Access Compliance Report

Public Rights-of-Way

(Curb Ramps)

Intersection ID: 10020011	Main Street: ARROWPOINT_BV	Cross Street: N/A	Location: W
ADA ID: 070685F63B22	Ramp Type: Perp	Initial Pass/Fail: Fail	Overall Compliance: No
Codes/Mitigation Info/Possible Solution		Field Measurements/Component Compliance	
Severity Score: 33.75

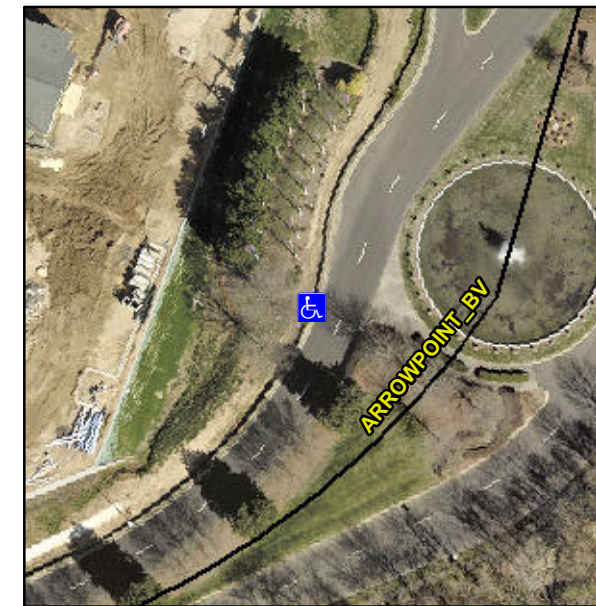
Not Found, R304.5.1, R304.2.2

Compliance	Description	Data	Compliance	Description	Data
N/A	Ramp Length (in)	54.0	No	Ramp Slope (%)	14.1
No	Ramp Width (in)	41.0	Yes	Ramp XSlope (%)	1.6
N/A	Flare Type LT	N/A	N/A	Flare Type RT	N/A
N/A	Flare Slope LT (%)	N/A	N/A	Flare Slope RT (%)	N/A
N/A	Flare Traversable LT?	N/A	N/A	Flare Traversable RT?	N/A
N/A	Landing Length (in)	N/A	N/A	DWS Provided?	N/A
N/A	Landing Width (in)	N/A	N/A	DWS Contrast?	N/A
N/A	Landing Slope (%)	N/A	N/A	DWS Length (in)	N/A
N/A	Landing X Slope (%)	N/A	N/A	DWS Full Width?	N/A
N/A	Landing Curb? (Y/N)	N/A	N/A	DWS Offset (in)	N/A
N/A	Shared Landing?	N/A			
N/A	Gutter Ponding?	N/A	N/A	Gutter Slope (%)	N/A
N/A	Gutter Lip Ht (in)	N/A	N/A	Gutter X Slope (%)	N/A
N/A	Painted X Walk1?	No	N/A	Painted X Walk2?	N/A
	X Walk 1 Direction	To E		X Walk 2 Direction	N/A
N/A	X Walk 1 Width (in)	N/A	N/A	X Walk 2 Width (in)	N/A
	X Walk 1 Slope (%)	5.1		X Walk 2 Slope (%)	N/A
	X Walk 1 X Slope (%)	2.0		X Walk 2 X Slope (%)	N/A

Remove & Replace Entire Ramp.
